**PLANNED UNIT DEVELOPMENT
& SUBDIVISION STAFF REPORT****Date: May 7, 2009**

<u>DEVELOPMENT NAME</u>	Northside Ltd/Joint Venture Subdivision
<u>SUBDIVISION NAME</u>	Northside Ltd/Joint Venture Subdivision
<u>LOCATION</u>	3050 Dauphin Street (North side of Dauphin Street, 355'± West of North Sage Avenue, extending to the West side of North Sage Avenue, 180'± North of Dauphin Street)
<u>CITY COUNCIL DISTRICT</u>	District 1
<u>PRESENT ZONING</u>	B-3, Community Business District
<u>AREA OF PROPERTY</u>	3 Lots/8.2± acres
<u>CONTEMPLATED USE</u>	Planned Unit Development approval to allow shared access between two building sites, and Subdivision approval to create three legal lots from three metes and bounds parcels.
<u>TIME SCHEDULE FOR DEVELOPMENT</u>	Immediately
<u>ENGINEERING COMMENTS</u>	Must comply with all storm water and flood control ordinances. Any work performed in the right of way will require a right of way permit.
<u>TRAFFIC ENGINEERING COMMENTS</u>	Driveway number, size, location, and design to be approved by Traffic Engineering and ALDOT and conform to AASHTO standards. To discourage cut-through traffic, traffic calming should be installed on the access drive.

SITE PLAN

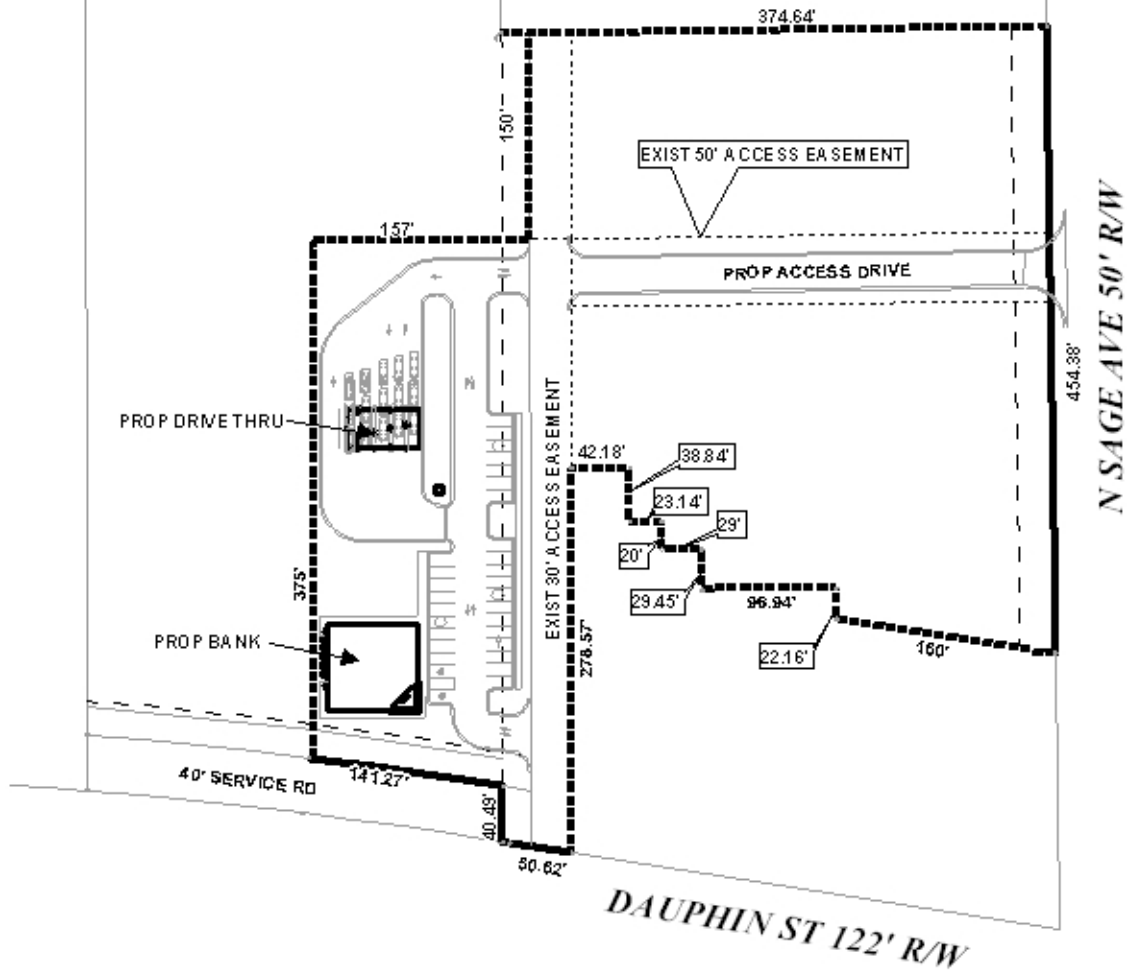
The site illustrates the proposed development for Lot 2A, which consist of a 3,820 square foot building, and associated parking spaces; however, waste receptacles, such as a dumpster, are not reflected on the site plan, nor sidewalks or trees and landscaped areas. As the proposed development will be new construction, the site must be developed to comply with the Zoning Ordinance, including the provision of trees and landscaping.

The 25-foot minimum building setback lines are depicted on the Final Plat; therefore, the illustration of the 25-foot minimum building setback line is required to be depicted on the Final Plat, if approved.

- 1) the submission of full Planned Unit Development applications prior to the development of Lots 1A and 3A;
- 2) the submission of a revised PUD site plan with the placement of a note stating that the traffic calming devices to be installed prior to the issuance of a Certificate of Occupancy for any new development within the subdivision; and
- 3) full compliance with all other municipal codes and ordinances.
